Rev D	01.11.16	Issued for planning submission
Rev C	12.09.16	Issued for planning submission
Rev B	07.07.16	Issued for planning submission
Rev A	03.12.15	Issued for planning submission

Project **7 Warwick Court**

Drawing Title: **Proposed Street Elevation**

Drawing No. **P_08** Rev. **D**

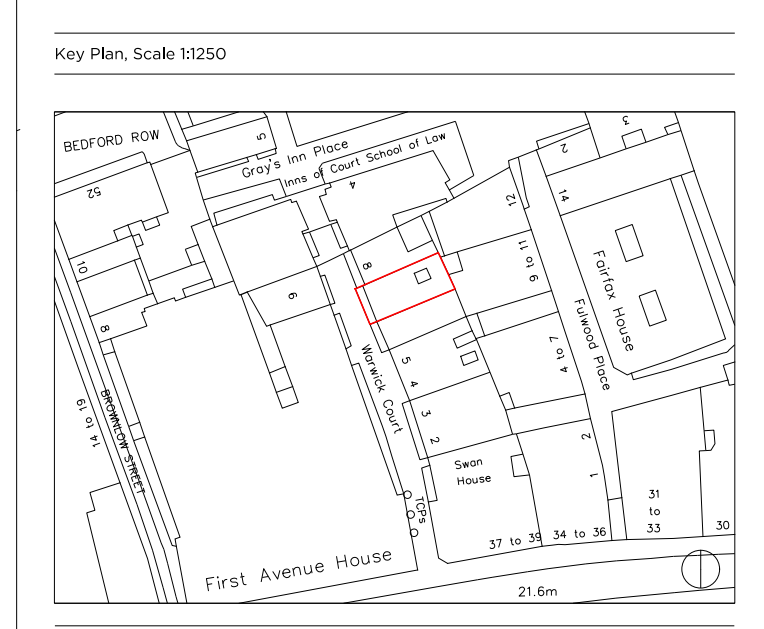
- C. Revision Notes:**
- C1 Existing Dormer windows to be retained.
 - C2 Railings and lightwell stair to remain in existing position.
- D. Revision Notes:**
- D1 Addition of airbrick (215x140mm)
